SUBJECT: AMENDMENT NO. 106 TO FACILITY OPERATING LICENSE NO. DPR-74: SHUTDOWN
MARGIN REQUIREMENTS (TAC NO. 71050)

DONALD C. COOK NUCLEAR PLANT, UNIT NO. 2

Amendment No. 106
License No. DPR-74

SAFETY EVALUATION BY THE OFFICE OF NUCLEAR REACTOR REGULATION
RELATED TO AMENDMENT NO. 106 TO FACILITY OPERATING LICENSE NO. DPR-74

Figure 3.1-3 REQUIRED SHUTDOWN MARGIN

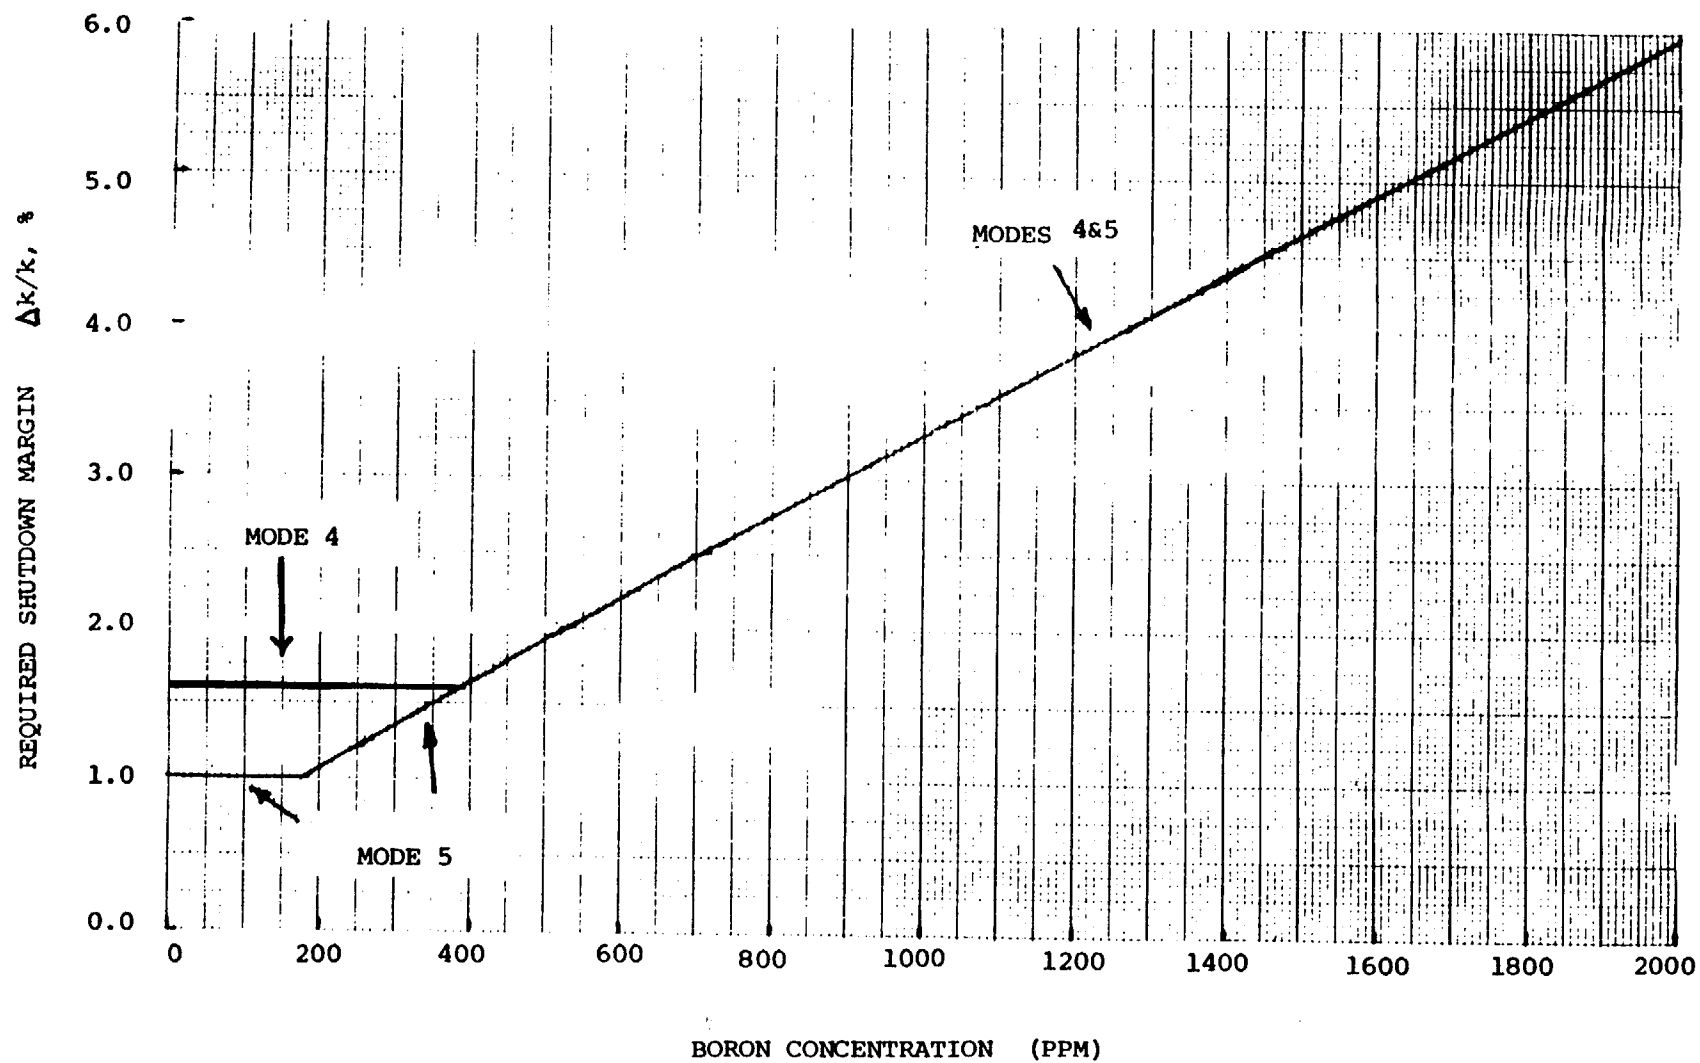
The present TS amendment was requested because ANF determined that the equation used in the referenced analysis to calculate the change in reactivity between initial (shutdown) and final (critical) boron concentration was incorrect. ANF assumed discrete values for the differential boron worth, rather than values based on the average boron concentration between the initial and final conditions. The use of discrete differential boron worth values results in a less accurate prediction of the time to loss of minimum shutdown margin, relative to the use of an average differential boron worth.

The licensee has proposed a revised Figure 3.1-3, based on a more accurate determination of boron worth performed by ANF. The new ANF analysis determines boron worth using ANF's NRC-approved XTGPWR computer code, which is ANF's standard code for reload neutronics calculations. The curve is bounding with respect to the upcoming Cycle 7 reload.

As with the previous Figure 3.1-3, the revised figure assures the operator has 15 minutes to respond to a boron dilution accident before shutdown margin is lost. The revised shutdown margin requirements are greater than or equal to the previous requirements at all points.

Since the revised requirements are conservative with respect to the previous requirements, and since the revised curve was developed using an NRC-approved neutronics code, the staff finds the change acceptable.
